This letter is submitted on behalf of the City of Hermosa Beach, in response to the Draft Environmental Impact Report (“DEIR”) for the West Basin Municipal Water District Ocean Water Desalination Project (“the Project”). The City Council of Hermosa Beach has voted in the past to oppose this project, because it would have negative impacts on the environment, and because it is an unduly expensive and unnecessary water supply option.<sup>1</sup>

**I. The Project DEIR fails to present substantial evidence that marine biological and water quality impacts are less than significant or can be mitigated.**

**Figure 1. Comparison of the Energy Intensity of California Water Supplies<sup>48</sup>**

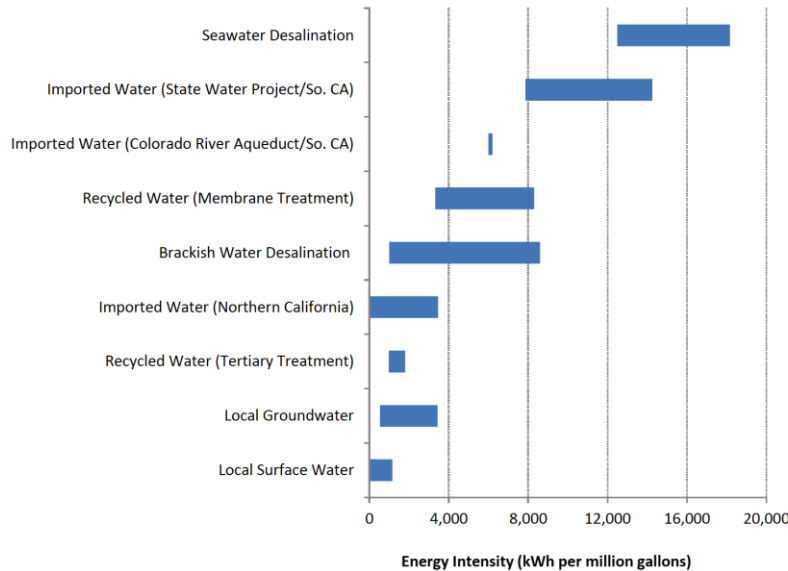
Finally, the DEIR assesses the Project's energy use only in comparison to imported water, rather than comparing the energy use of seawater desalination to the even less energy intensive options. This is justified by the need for a diversified water supply, but diversification can still be accomplished without the use of this large-scale Project. The DEIR should not just compare the energy impacts of the Project to imported water, but instead to the range of other alternatives.

Despite the length of the document, the DEIR does not reference the preeminent analysis comparing the energy and GHG emissions of seawater desalination to other water supply options, conducted by the Pacific Institute.<sup>49</sup> This is an important example of significant gaps in evidence utilized by the DEIR in conducting its analysis.

In consideration of these issues with the DEIR, it appears that the Project would have significant, unavoidable, energy impacts. We request that West Basin re-evaluate the energy impacts of the Project, with these points in mind.
